**NRC Response to
FAQ 12-01 (Withdrawn) re. Columbia DG3 Failure
For August 29, 2012 ROP WG Meeting**

Plant: Columbia Generating Station (CGS)

Performance Indicator: MS06

FAQ 12-02
Counting of Compensatory Hours for Perimeter Intrusion Detection System

Figure 1, Load and current profile during DG3 Operation on 2/28/10

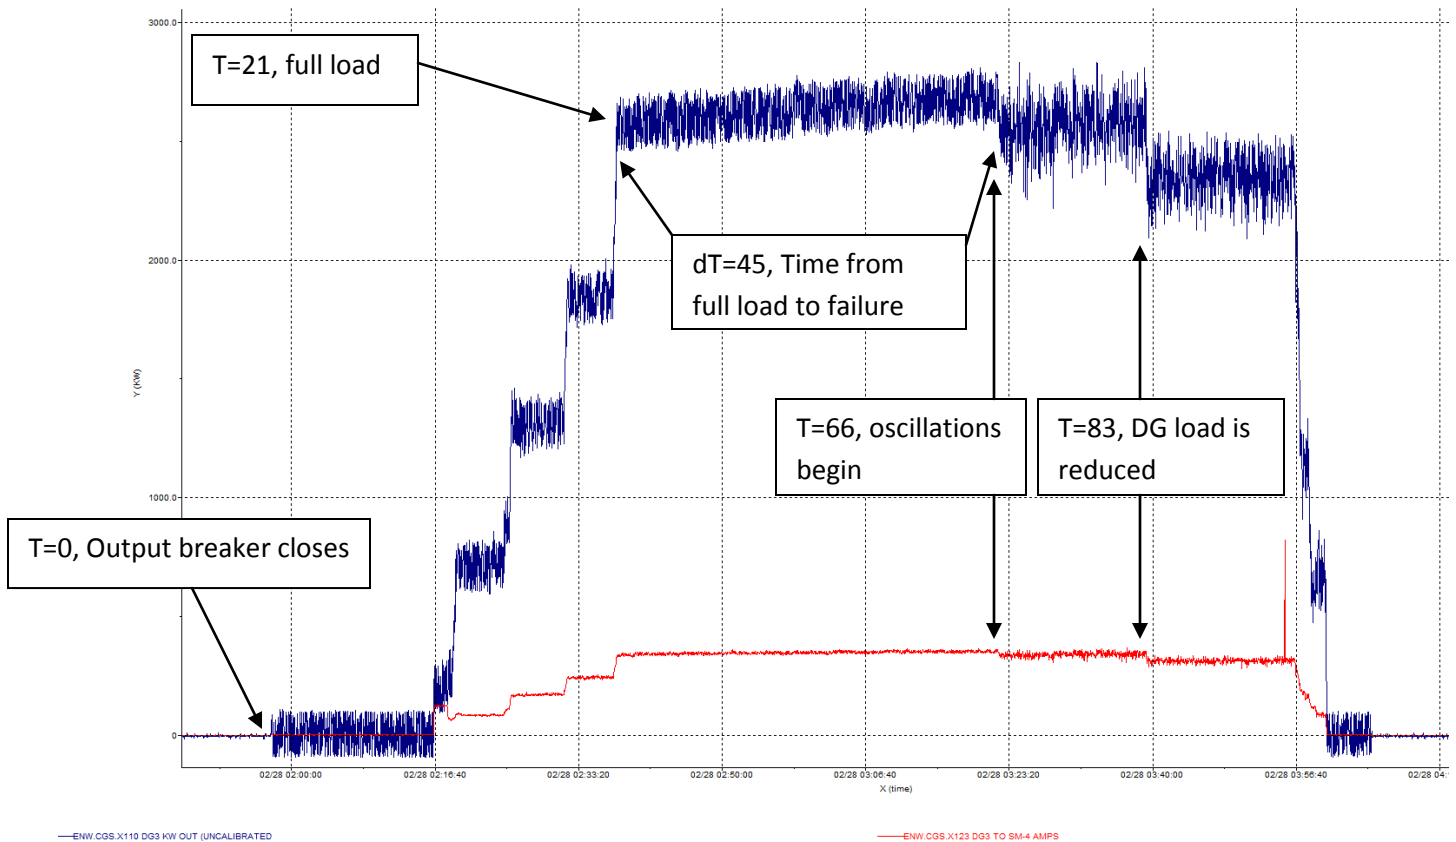
CGS and the CGS NRC Senior Resident Inspector (SRI) do not agree that CGS properly reported the February 28, 2010 EDG failure. NEI 99-02 defines “EDG failure to load/run”. In part, it states: “Given that it has successfully started, a failure of the EDG output breaker to close, to successfully load sequence and to run/operate for **one hour** to perform its monitored functions.” The intent of this FAQ is to clarify that based on the guidance available at the time the start time for the “one hour” period begins once the EDG has completed its load sequence and is loaded (at T=21 and not at T=0 (as per figure 1)). Based on the response to FAQ Number 487, CGS understands that as of 1/1/2012 the “one hour” period begins at output breaker closure (T=0 per figure 1).

Based on the timeline associated with the February 28, 2010 diesel failure, the resident inspectors believe that evaluation under the existing guidance at the time of the issue (NEI 99-02, Revision 6) should have determined that this particular diesel failure is an “EDG failure to run”. The two key points

The NRC staff evaluated this issue based on the characteristics of the EDG failure (i.e., the functional response of the EDG and the failure mechanism), and applying reasonable decision-making using the guidance in effect at the time of the failure. The oscillations were caused by foreign material in the governor – a condition that had existed for several years and that did not impact prior breaker closure and sequencing operations. Figure 1 in this FAQ shows that the oscillations did not occur during the breaker closure or the load sequencing or gradual loading action. Rather, the oscillations occurred 66 minutes after breaker closure and 45 minutes after the full load (for purposes of the test run) was achieved, which is indicative of a challenge to the EDG’s ability to continue to run for its mission time. Even though the foreign material existed in the governor for several years, the EDG had started and load sequenced several times without failure. Therefore, this failure appears to have been exacerbated by the running (vice start or loading) of the EDG.

Because Figure 1 data is more reflective of an EDG failure-to-run for its mission time rather than a loading failure, the EDG failure at Columbia should have been reported as a failure-to-run.

Based on the guidance available at the time of the event (Feb 2010), the one hour time period referred to in the definition of "EDG failure to load/run" begins once the EDG has successfully load sequenced to fully loaded conditions. Based on the response to FAQ Number 487, given the same event today (after 1/1/2012), the "one hour" time period begins at output breaker closure.
